## TECHNICAL MEMORANDUM

**Project No.:** 093-81962

**RE: ROSEMONT COPPER PROJECT, TECHNICAL REVIEW OF SITE WATER MANAGEMENT UPDATE**

**FIGURE 2**  
**DETAIL OF THE FLOW-THROUGH INLET**

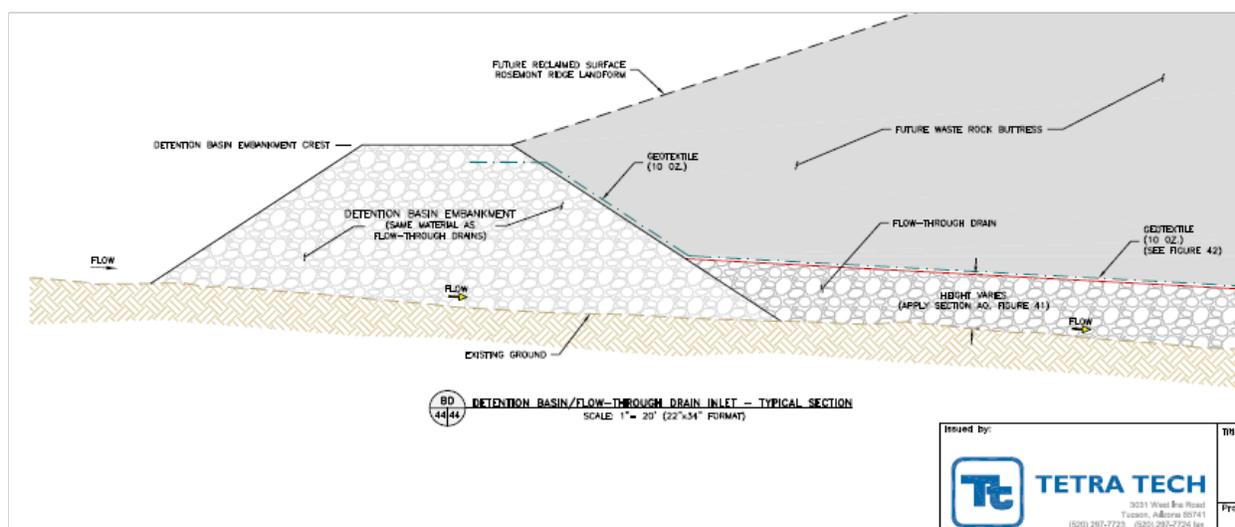
Golder was requested to specifically comment on the entrance arrangement to the flow-through drains, shown in Figure 2. It is our opinion that sediment from upstream will likely clog the berm over the medium to long term. This is due to the fact that no upstream provision is made to prevent sediment from entering the berm.
